July 16, 2012

Central Coast Regional Water Quality Control Board (CCRWQCB)

Subject: Comments regarding update of the LOWWP Recycled Water Management Plan (RWMP); Dewatering Plan, and seawater intrusion mitigation scheduled for September 6, 2012.

**WATER LEVEL AND WATER QUALITY
SAMPLE LOCATIONS AND AREAS OF
DEPTH TO WATER LESS THAN 10 FEET**
Los Osos Wastewater Project
San Luis Obispo County, California

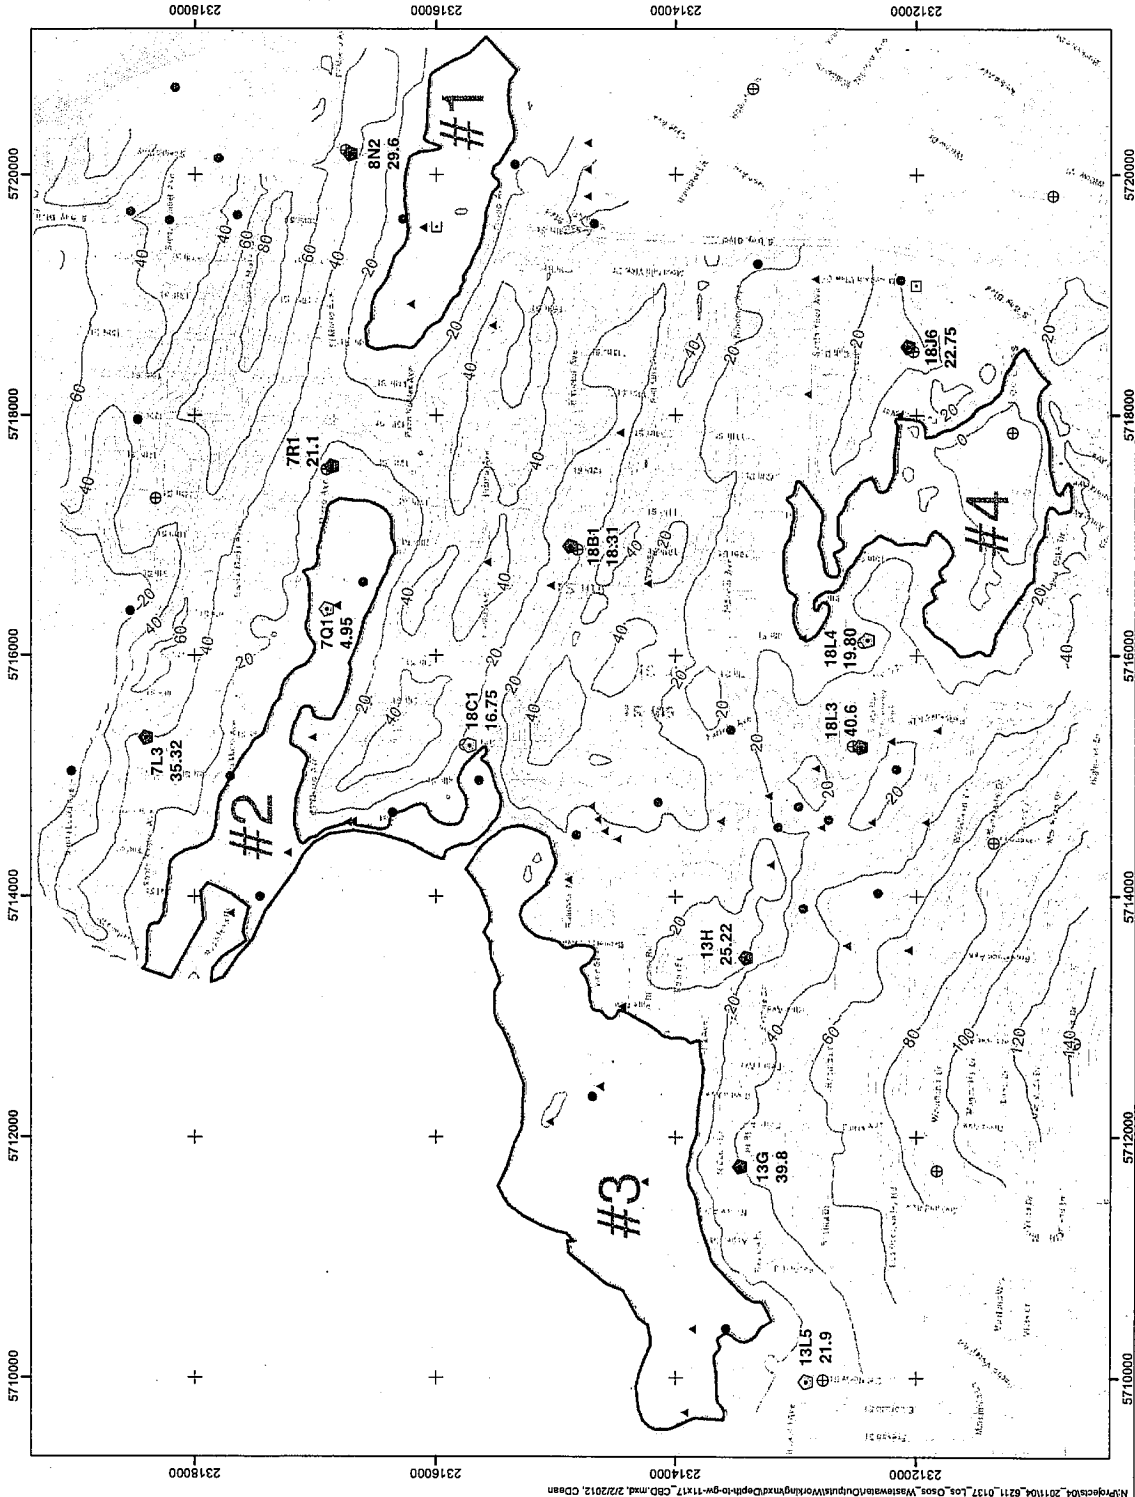
1. when Area #1 (from attached high groundwater map) is dewatered, there will be an immediate adverse impact on the wetlands near Willow and Los Osos Creeks and other ESHA along the estuary, due to major reductions in perched groundwater flows.

2. when Area #4 (from attached high groundwater map) is dewatered, there will be an immediate adverse impact on the wetlands near Willow and ultimately other ESHA along the estuary, due to major reductions in perched groundwater flows.

3. Areas #2 and #3 (from attached high groundwater map) is dewatered, there will be an immediate adverse impact on the wetlands and ESHA along the estuary, due to major reductions in perched groundwater flows. I am also very concerned that seawater intrusion will be immediate along these areas. The County seems very aware of this as mentioned in the CDM Report where it is stated "When dewatering areas closer to the coast, higher pumping rates may be needed, as more groundwater is available in these

locations through inflow of seawater." the County only seems concerned with this problem from a dewatering objective but shows no concern regarding its adverse effects on the environment. What will happen to the plant life along the edge of the bay when this once fresh water turns brackish or full on seawater? Where is the pumped water going to be placed? It obviously can't be put on land as it will destroy the soil and contaminate the water. The only alternative is to pump it into Morro Bay National Estuary, but if it is pumped into the estuary, it will more than likely have to be treated to meet water quality standards. If the pumps are going at full capacity they will be pumping 5.8 AFD in a single area. What is the cost and practicality of treating this much water on a daily basis for who knows how long. And how is this water going to be disposed of in the bay at these volumes without stirring up the bay muds and causing harm to the estuary. Where is the plan for disposal to the bay when ultimately we know this will be the only solution? What is the process and likelihood of getting permits for bay disposal?
